Please accept this as my objection to both Applications [2019/1773/P](#) & [2019/1772/P](#) for discharging both condition 3 and 15 respectively.

Application: [2019/1772/P](#) - Condition 15, and Application: [2019/1773/P](#) - Condition 3.

Fig 2. Original Application 2017/3838/P - From Drawing LL443-150-0111

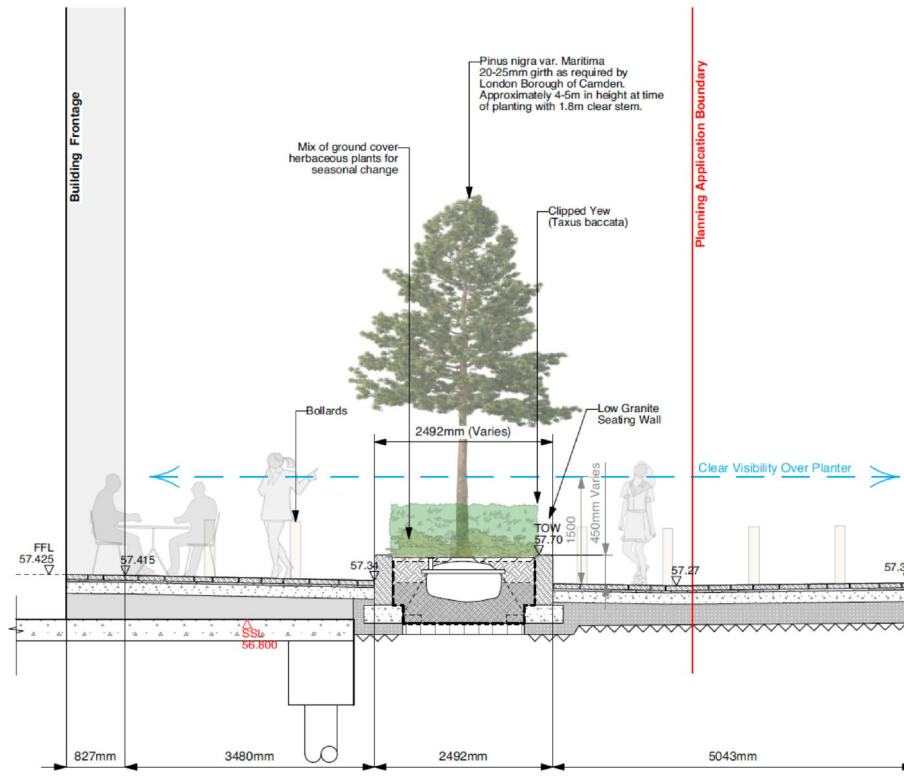
Having compared the current application [2019/1772/P](#) with the original application: [2017/3838/P](#) <http://camdocs.camden.gov.uk/HPRMWebDrawer/PlanRec?q=recContainer:2017/3838/P> that was withdrawn in July 2017, in order to partially discharge condition 15, I see that no improvements other than the planter is likely to be less effective in mitigating strong winds because it is smaller [Fig 2.]

There are two deciduous trees, less shrubs and still only one pine tree - despite RWDI recommending "planters with evergreen trees/shrubs" to provide maximum density. [5.2.3].
